COPYRIGHT THEODORE K. GUY ASSOCIATES PC	THEODORE K GUY ASSOCIATES PC ARCHITECT AND PLANNER P.O. BOX 1149 TRUCKEE, CALIFORNIA 95734 (916) 587-3829 FAX (916) 587-3825
DECK REVISION	
SUBMITTAL	
10-14-94 DRAWN RKG CHECKED RKG REVIEWED 6-9-94	
MOUNTAIN HOUSING GROUP LOT #442 TELLURIDE MOUNTAIN VILLAGE	
DATE REVISIONS

A2.3

1 BUILDING 3 - UPPER LEVEL
1/8"=1'-0"

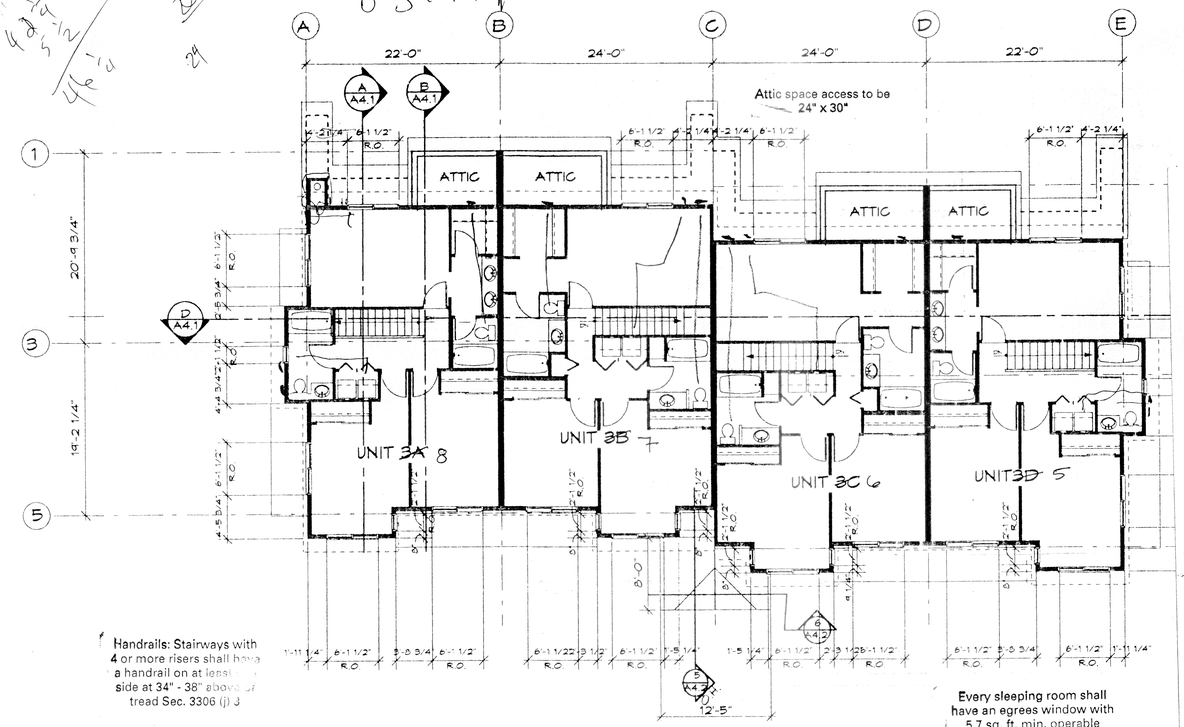
Handrails: Stairways with 4 or more risers shall have a handrail on at least one side at 34" - 38" above of tread Sec. 3306 (j) 3

Every sleeping room shall have an egrees window with 5.7 sq. ft. min. operable area. Min. 20" wide and 24" high dimensions are required. Sill height max. 44" off floor Sec. 1204

2 BUILDING 3 - LOWER LEVEL
1/8"=1'-0"

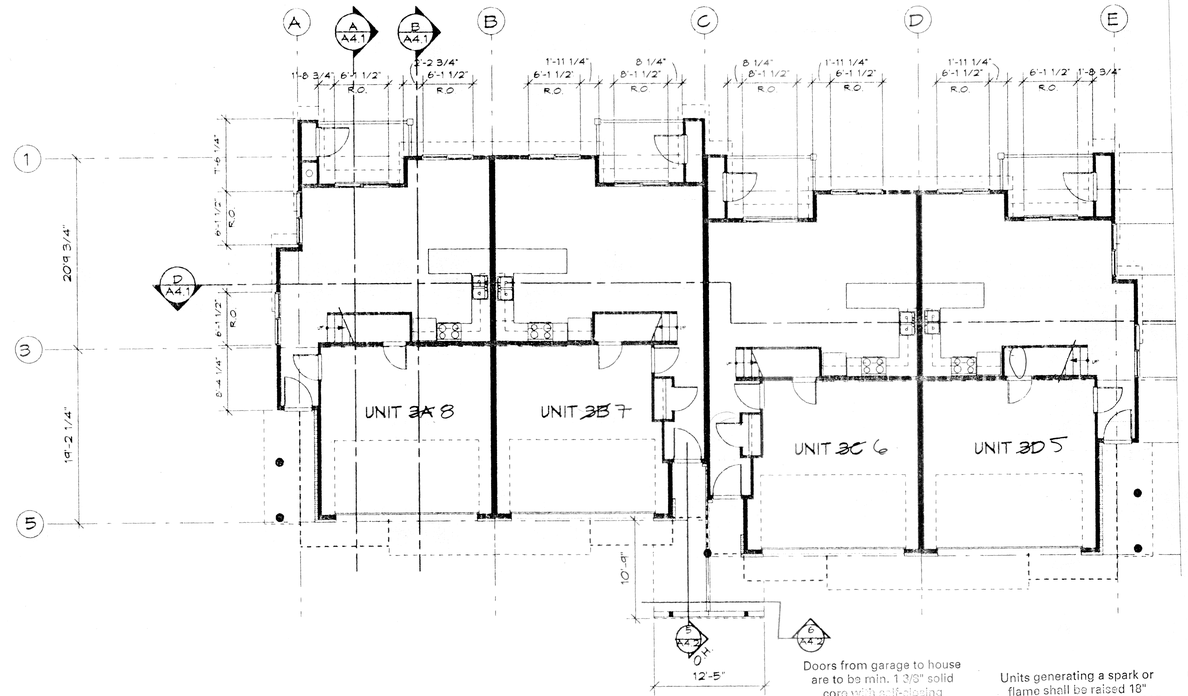
Doors from garage to house are to be min. 1 3/8" solid core with self-closing device, weatherstripped and threshold Sec. 503 (d) 3

Units generating a spark or flame shall be raised 18" above the floor Sec. 508 UMC

Garage and house shall be separated by 1 hour fire resistive construction.

Stairways are to have a max. rise of 8", min. run of 9", min. headroom of 6'8" and min. width of 36" Sec. 3306 (b) (c)
